**Official Transcript of Proceedings**  
**NUCLEAR REGULATORY COMMISSION**

Title: Advisory Committee on Reactor Safeguards  
Kairos Power Licensing Subcommittee

Date: Tuesday, April 4, 2023

KAIROS POWER LICENSING SUBCOMMITTEE

# 5.1 Primary Heat Transport System: Description

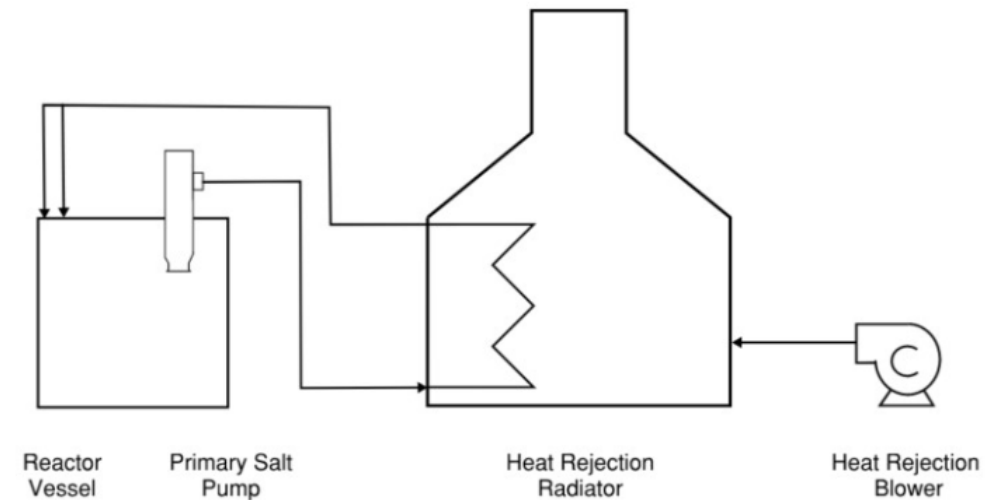
3 MEMBER HALNON: So just a question for  
4 clarification, make sure I have it in -- pictured my  
5 in mind. So the hot leg let's say comes into the top  
6 of the heat exchanger and out the bottom comes two  
7 cold legs?

2 MR. ZWEIBAUM: That's correct.

# 7.1 Instrumentation & Controls Systems: Overview

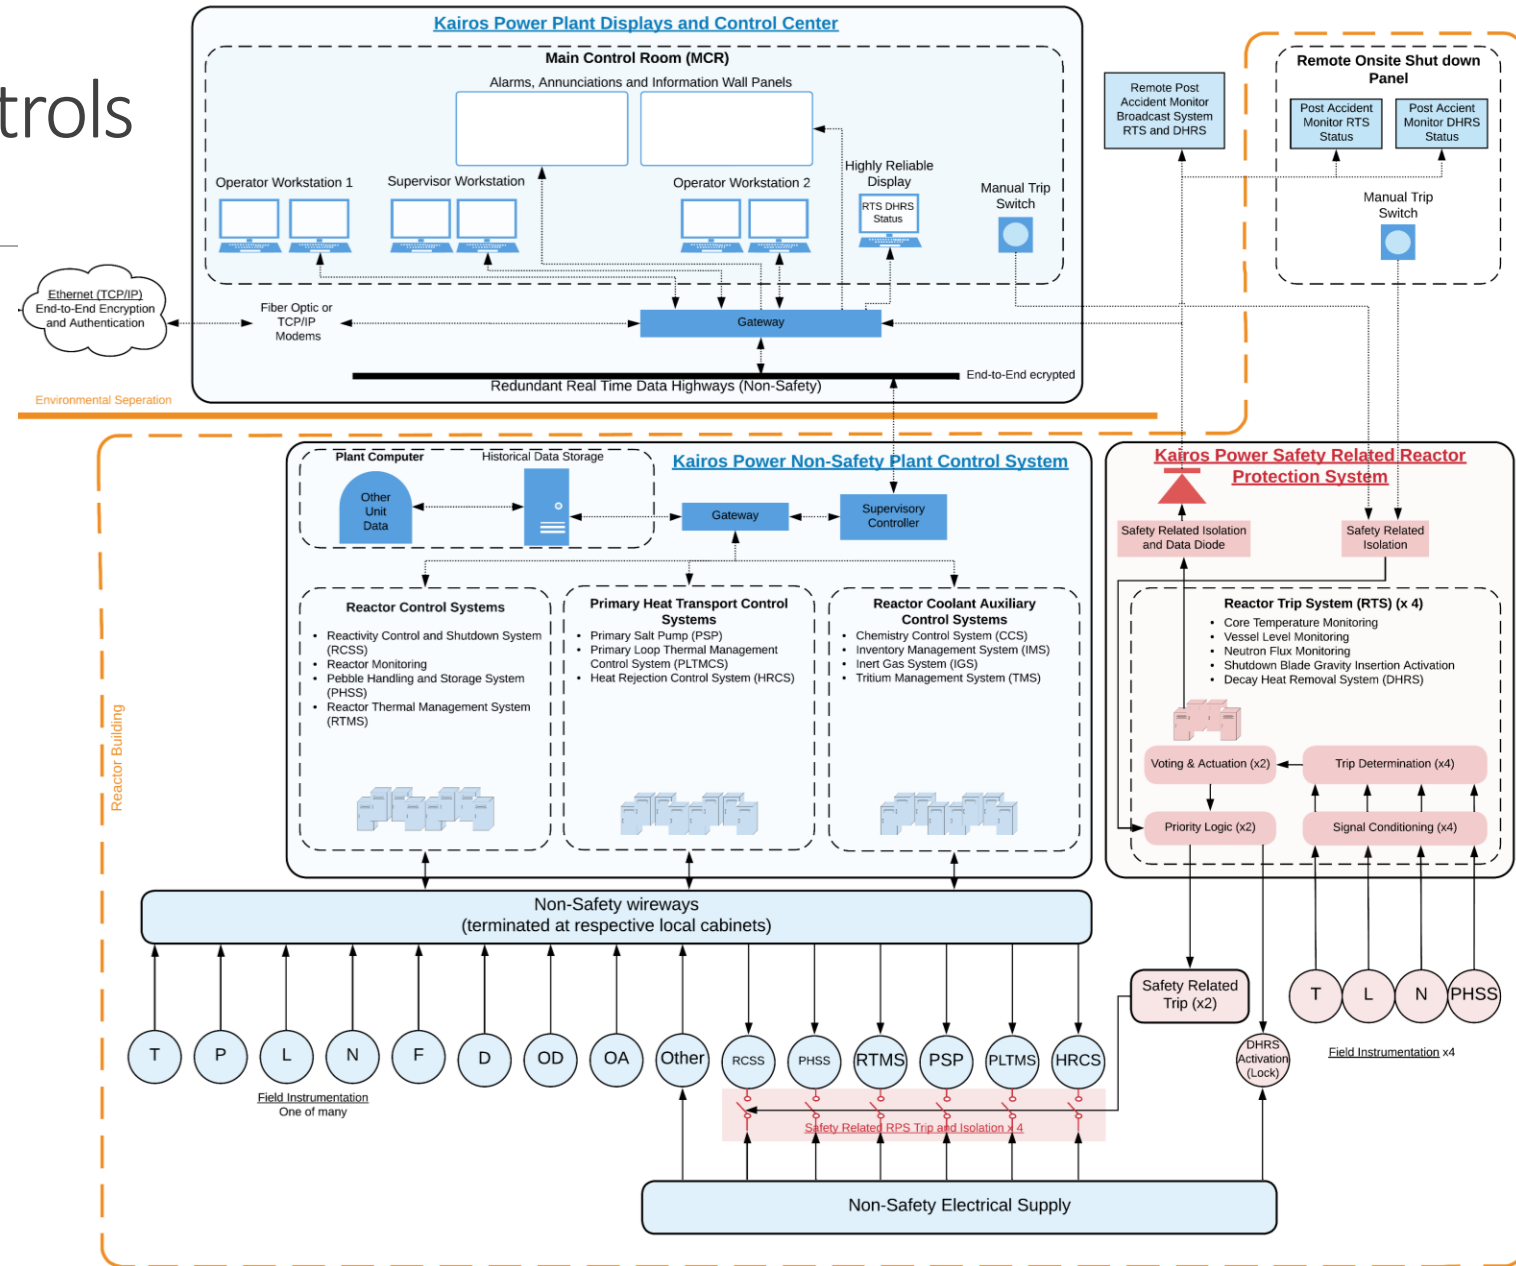
3 MEMBER BROWN: Please. This is Charlie  
4 Brown again. Can you go back to the previous slide?  
5 Oh, no, go all -- now that you're on the plant control  
6 system, can you go back to the overall figure? That's  
7 it. That can't be. Does everybody have a bigger  
8 picture of this?

10 MEMBER BROWN: Okay. I'll just bring this  
11 up now from a single failure standpoint. All the data  
12 from the plant control system goes up into a  
13 distributed, as you all -- let me see it to make sure  
14 I get the -- it's a microprocessor based distributed  
15 control system --

17 MEMBER BROWN: -- individually controls  
18 plant systems using inputs. That's the -- but all  
19 that data goes up into a gateway. Then it goes to the  
20 supervisory controller, then up into this redundant  
21 dual -- I can't read the rest of it. I've got to get  
22 the right chart here. Real-time data highway, and  
23 then through another gateway and up into the main  
24 control room.

1 everything. If that bus fails or the gateways fail,  
2 there's no data going to the main control room. That  
3 seems to be not a particularly useful design approach  
4 to maintain your overall visibility of what's going on  
5 in the plant.

2 MEMBER BROWN: Yeah, the main figure for  
3 the overall plant stuff made a couple of what it turns  
4 out to be fairly significant changes relative to the  
5 data diodes and where they'd be and how they're fed,  
6 through gateways or not through gateways. And they've  
7 now taken them out of the gateway operation.

12 MEMBER BROWN: Yes. You didn't show --  
13 going back to the big diagram, this is a small  
14 question, the overall --

19 MEMBER BROWN: In the main control room,  
20 you show, you know, two operator workstations and a  
21 supervisor workstation. And in your comments relative  
22 to the single bus sending all that data, you said  
23 that's, you just didn't show the redundancy you intend  
24 to incorporate.

1 intention to feed those workstations with both of the  
2 redundant, independent busses bringing all that plant  
3 control system data up to the main control room so  
4 that you can select them. You don't want them to  
5 interfere. But I presume you can select one bus or  
6 the other to maintain continuity.

10 MR. CILLIERS: Yeah, I'd like to respond  
11 to it. Thank you very much for that. That is  
12 something that from this architecture we did not  
13 include or show any of the redundancy systems.

14 In our subsequent development, and I did  
15 not feel that it's necessary to put that in the piece  
16 or at this stage, but in further developments of the  
17 architecture we do indicate redundant, both redundant  
18 controllers on the plant control system side. So we  
19 have two controllers. So, if there's a fail, it moves  
20 over to the other controller, as well as redundant  
21 highways. So thank you very much for that. We've  
22 also included that into our design that will be  
23 presented in the OLA phase.

7 MR. CILLIERS: Yeah, we haven't made a  
8 final decision on how we will be using the redundant  
9 systems. So I will not comment on that right now.

## Hermes PSAR 8 Electrical Design

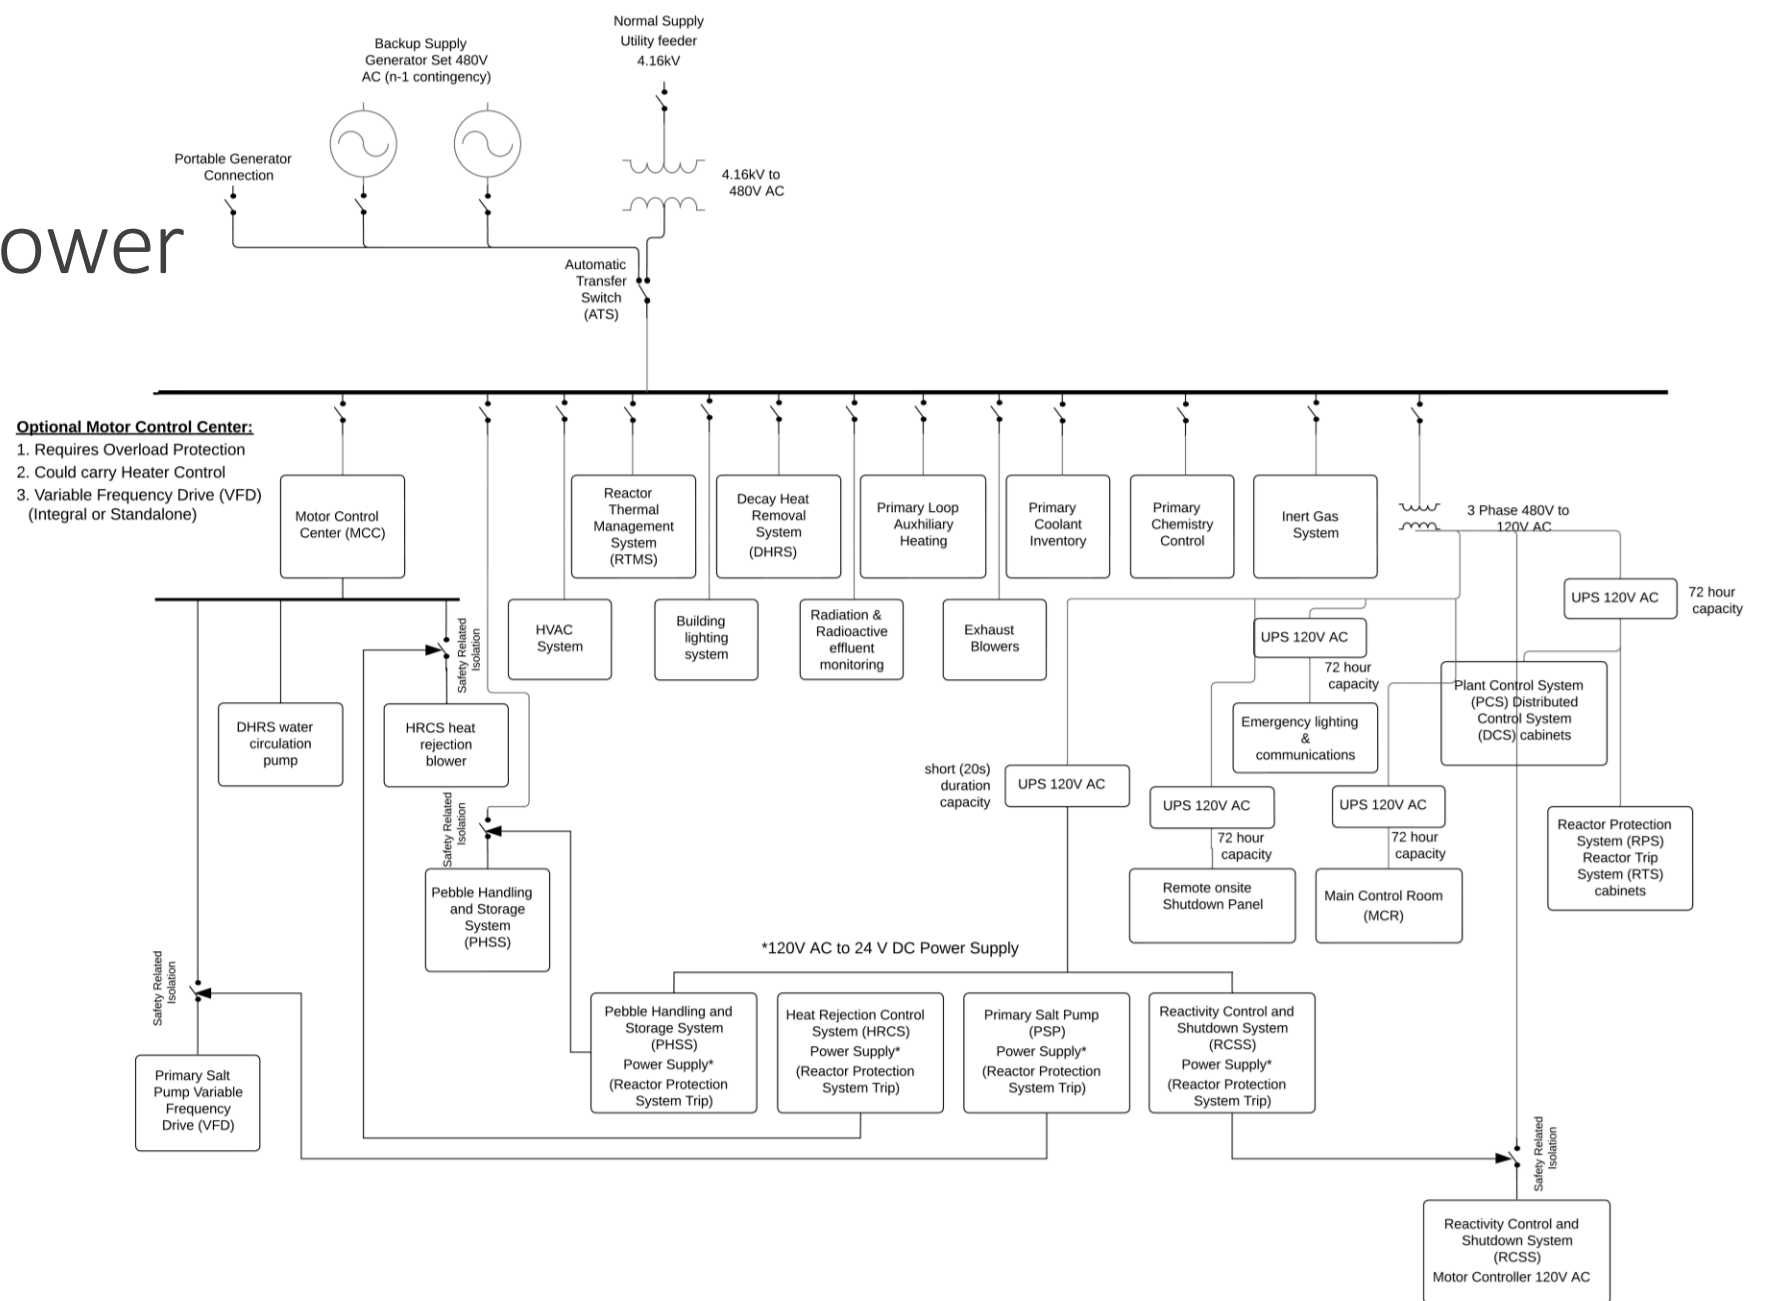
2 I understand the backup goes away. Right  
3 now you show in Chapter 8 a UPS for that. And then  
4 you show in the Chapter 8 discussion, as well as the  
5 figure, that it can maintain itself for 72 hours on a  
6 UPS performance basis.

21 MEMBER BROWN: All right. That's fine.  
22 I just wanted to make sure. There's little subscripts  
23 under the UPS in the figure. So thank you.

1           The purpose of that 72 hours is, of  
2 course, we would like to have power during any event.  
3 Although we do not rely on it, it's better to have it  
4 and to be able to monitor the system continuously.  
5 But it doesn't provide any safety functions.
